PRODUCT BULLETIN # 20645

Issue Date: 18-Sep-2014

TITLE: TO-220 221A-09 Case Outline Change

TO-220
CASE 221A-09
ISSUE AG

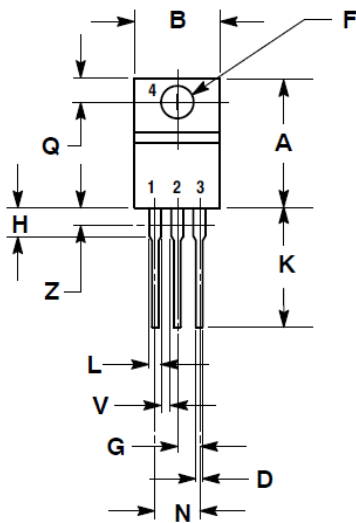
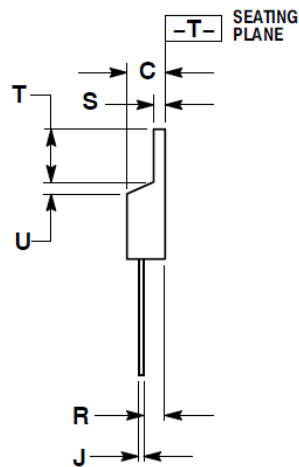
TO-220 (Case 221A-09)								
	Current				New				Reason for Change
DIM	Inches		Millimeters		Inches		Millimeters		
	Min	Max	Min	Max	Min	Max	Min	Max	
A	0.570	0.620	14.48	15.75	0.570	0.620	14.48	15.75	
B	0.380	0.405	9.66	10.28	0.380	0.415	9.66	10.53	Meet Subcon Spec
C	0.160	0.190	4.07	4.82	0.160	0.190	4.07	4.83	Meet Subcon Spec
D	0.025	0.036	0.64	0.91	0.025	0.038	0.64	0.96	Meet Subcon Spec
F	0.142	0.161	3.61	4.09	0.142	0.161	3.61	4.09	
G	0.095	0.105	2.42	2.66	0.095	0.105	2.42	2.66	
H	0.110	0.161	2.80	4.10	0.110	0.161	2.80	4.10	
J	0.014	0.025	0.36	0.64	0.014	0.024	0.36	0.61	Meet JEDEC Spec
K	0.500	0.562	12.70	14.27	0.500	0.562	12.70	14.27	
L	0.045	0.060	1.15	1.52	0.045	0.060	1.15	1.52	
N	0.190	0.210	4.83	5.33	0.190	0.210	4.83	5.33	
Q	0.100	0.120	2.54	3.04	0.100	0.120	2.54	3.04	
R	0.080	0.110	2.04	2.79	0.080	0.110	2.04	2.79	
S	0.045	0.055	1.15	1.39	0.045	0.055	1.15	1.39	
T	0.235	0.255	5.97	6.47	0.235	0.255	5.97	6.47

U	0.000	0.050	0.00	1.27	0.000	0.050	0.00	1.27	
V	0.045		1.15		0.045	0.000	1.15		
Z		0.080		2.04		0.080		2.04
